Technical Service Bulletin

Subject: OIL LEAKAGE FROM DRIVE BELT AUTO TENSIONER AND RATTLE NOISE FROM ENGINE COMPARTMENT	Bulletin No.: 01-019/19
	Last Issued: 11/26/2019

Example:

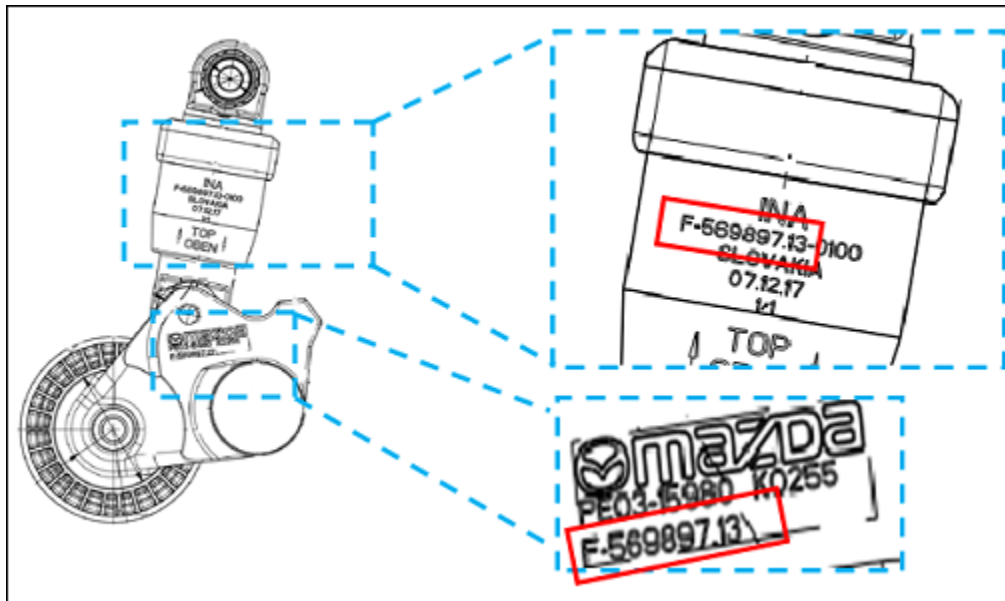
Part Number	Description	Qty.	Note
PET2-15-980	Tensioner-Auto	1	New modified drive belt auto tensioner can be identified by serial number F569897.13 . Refer to the example below.

NOTE: The last two digits of the serial are different between the old and new parts.

- New part serial number is **F569897.13**.
- Old part serial number is **F569897.10**.
